# UNITED STATES PATENT AND TRADEMARK OFFICE

10/586,386

# Office Action Summary

LEISING, GUNTHER

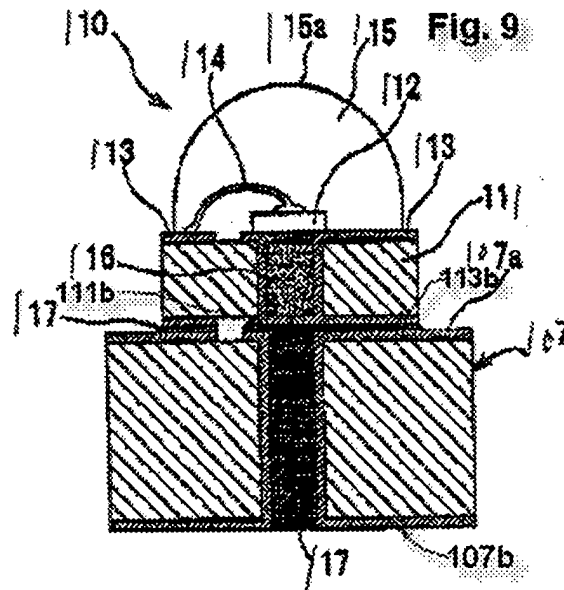
As for claim 1, Suehiro et al. shows (Fig. 2A; [0079]; [0085]) a light emitting diode 11, wherein at least one light emitting diode die 2 is arranged on a light emitting diode printed circuit board 3 with a die attach and the light emitting diode printed circuit board 3 has, on the side 3b opposite to the light emitting diode die 2, rear side contacts 4b which if appropriate are formed as plug contacts, wherein the rear side contacts 4b cover over at least half the area, preferably the entire area apart from the necessary exceptions, of the light emitting diode printed circuit board 3.

As for claim 2, the rear side contacts 4b are thermally, and if appropriate electrically, connected with the contact areas on the side of the light emitting diode
